APPEAL SUMMARY

Appeal ID: 14910

Project Address: 2390 SE Hawthorne Blvd

Building/Business Name: 23rd & Hawthorne Apartments

Roof Deck Assembly R7

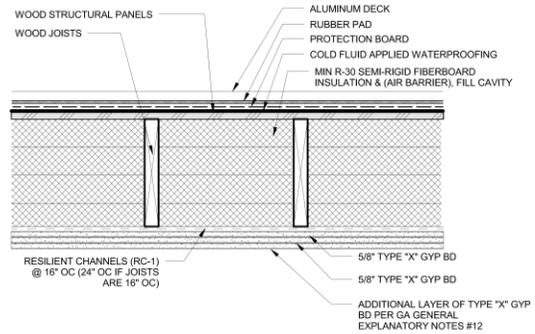
Proposed Design	<p>Proposed one-hour rated roof/ceiling assembly R7 at balcony deck (see attached Exhibit R7):</p> <ul style="list-style-type: none"> Aluminum deck Rubber pads Protection board Cold fluid applied waterproofing Wood structural panels Wood joists Min R-30 semi-rigid fiberboard insulation & air barrier, fill cavity Resilient channel Three (3) layers of 5/8" type X gypsum board <p>The STC and IIC ratings have been calculated by an acoustical engineer, see attached stamped letter, and satisfy the code requirements for sound transmission.</p>
Reason for alternative	This assembly is based on GA file 5529 which doesn't provide the STC or IIC rating.

3. Sound transmission ratings (STC / IIC) for 1 hour rated roof / ceiling assembly at balcony decks per Acoustical Engineer's analysis: Granted as proposed.

<p><i>Predicted Laboratory Measured Performance</i> (actual field conditions may be up to 5 points lower than values noted)</p>	<p>STC 59</p> <p>IIC 60</p>

SHEET TITLE: **ASSEMBLY F3**

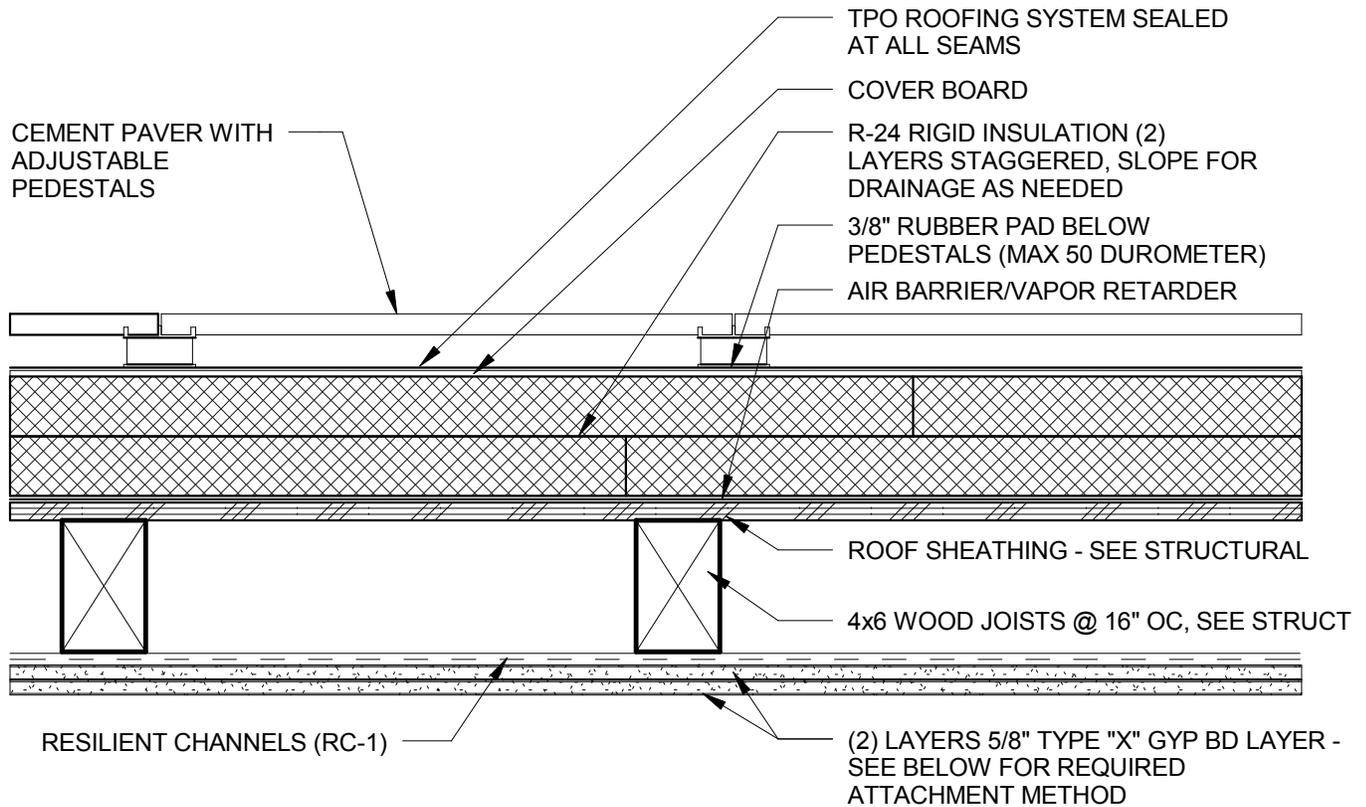
Proposed Design Proposed one-hour rated floor/ceiling assembly F3 at corridors (see attached exhibit F3):

Per our Fire Protection Engineer, stamped opinion attached, this corridor decking floor-ceiling assembly has at least one-hour of fire resistance. This conclusion is based on published rate of

1. Alternate 1 hour rated floor / ceiling assembly at corridors per engineered analysis: Hold for additional information. Appellant may contact John Butler (503-823-7339) with questions.

This engineer has been requested to provide an opinion of the fire resistance of Floor/Ceiling Assembly shown on Sheet F3 for the 23rd & Hawthorne Apartments project. The detail has been analyzed and shows at least 60 minutes (1-hour) of fire resistance.

To determine if 60 minutes of fire resistance is present in subject floor/ceiling assembly analysis of sacrificial wood char is selected. Published data shows wood chars at a rate of 1.4-1.5 inches per hour. Moreover this char rate has been written into Code for fastener protection. Code Reference: OSSC 2014 722.6.3.3 There is variation in char rates of specific species of wood and actual char is non-linear but these variations are minor.

After one hour of fire exposure the 3 inch wood decking has been reduced to a thickness of 1 inch. The floor/ceiling assembly after one hour of fire exposure becomes from top to bottom:

This reduced section assembly has been analyzed by the project structural engineer and using reasonable assumptions the assembly would remain in place. See the March 16, 2017 Structural Calculation Fire Design at Corridor Framing. This calculation is sealed by Hamid R. Afghan, P. E. (Structural Engineer).

SHEET TITLE: **ASSEMBLY R3**

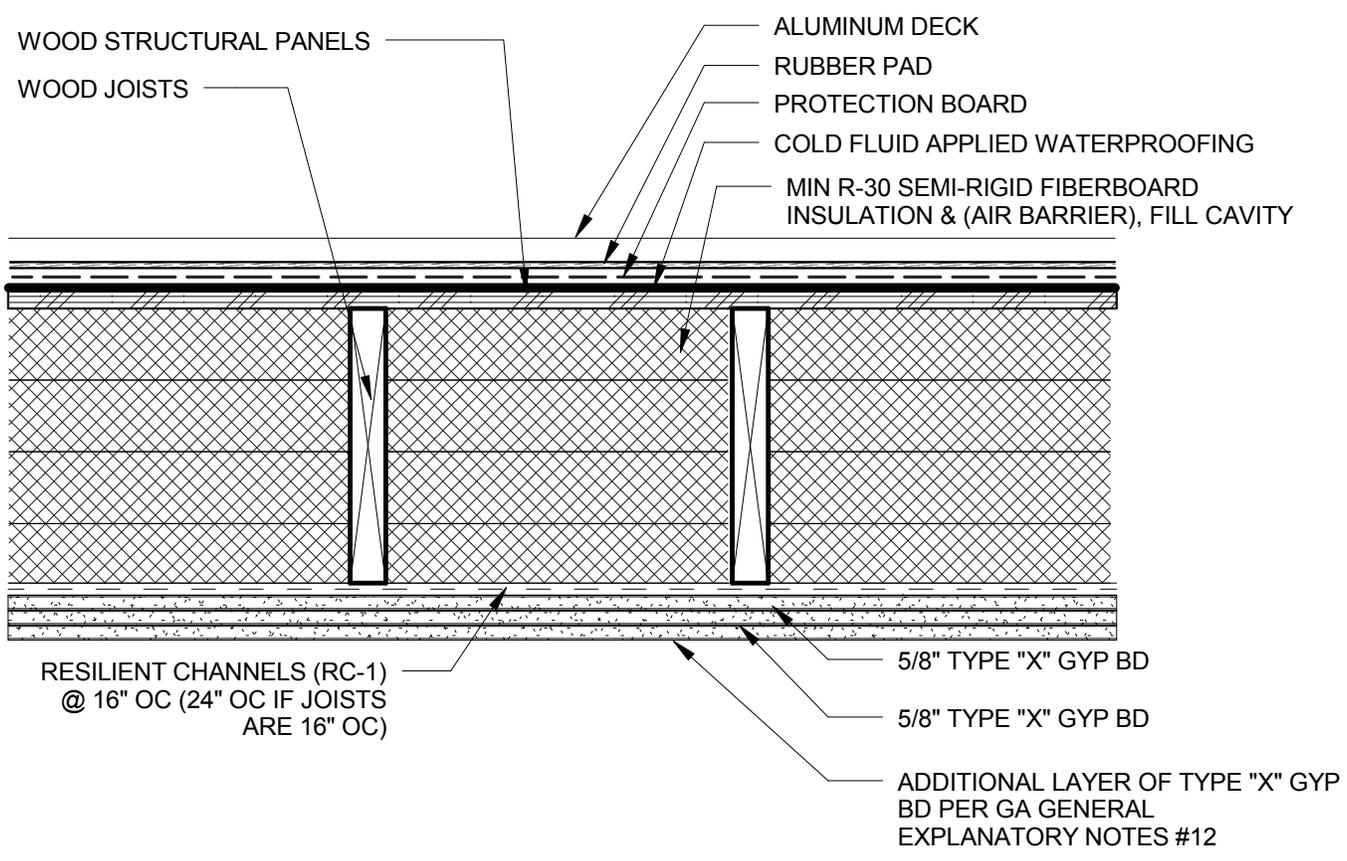
Proposed Design Proposed one-hour rated roof/ceiling assembly R3 at Amenity deck (see attached Exhibit R3):

The STC and IIC ratings have been calculated by an acoustical engineer, see attached stamped letter, and satisfy the code requirements for sound transmission.

Reason for alternative This assembly is based on calculated fire resistance per table 722.6.2(1) which doesn't provide the STC or IIC rating. The rubber pads under the paver pedestals provide superior sound insulation well above minimum required by code.

2. Sound transmission ratings (STC / IIC) for 1 hour rated roof / ceiling assembly at amenity deck per Acoustical Engineer's analysis: Granted as proposed.

Roof Deck Assembly R3

<p><i>Predicted Laboratory Measured Performance</i> (actual field conditions may be up to 5 points lower than values noted)</p>	<p>STC 54</p> <p>IIC 58</p>
